IMPORTANT TECHNICAL INFORMATION 01/2007

Implementation new filling valve

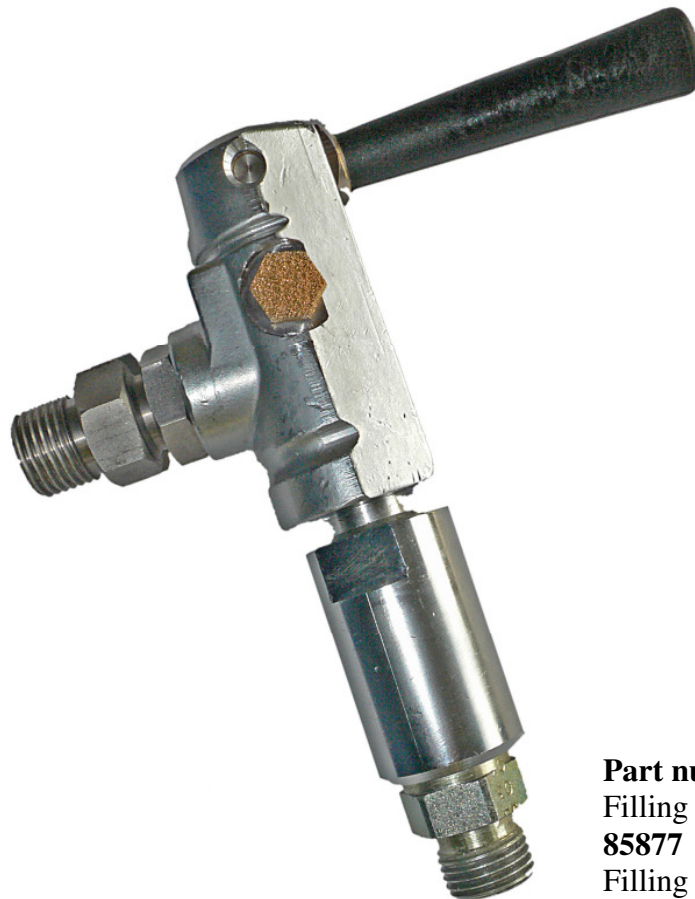
As of January 1st 2007 the redesigned construction will be available. The filling valve will be executed with a new pressure release system with silencer.

Part numbers:

Filling valve PN200:

85877

Filling valve PN300:

85878

Advantages of the redesigned filling valve:

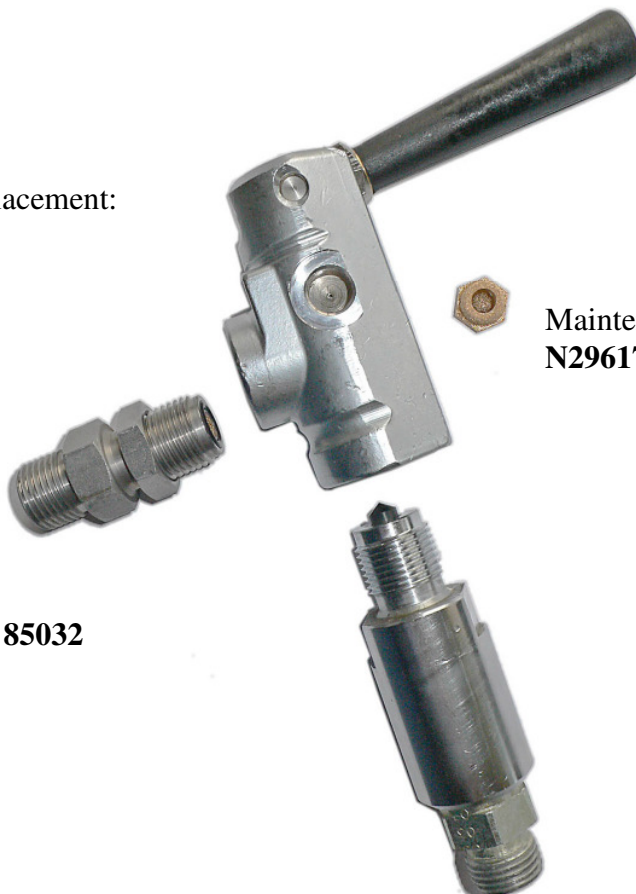
- ✓ More than 50% reduction of sound pressure (16 dB(A)).
- ✓ 100% retrofittable and replacable anywhere!
- ✓ Majority of parts separately available – most cost effective!
- ✓ Adapted maintenance and repair kits available as of now!
- ✓ Additionally the remaining sound pressure and vented air can be lead away from the valve over a G 1/8" inner thread connection!
- ✓ Low pitched tone whilst venting air, acceptable to human hearing!

Main body, replacement:
86100-KD

Maintenance kit:
N29617

Hose connection: **85032**

Direct connection PN 200: **85877**
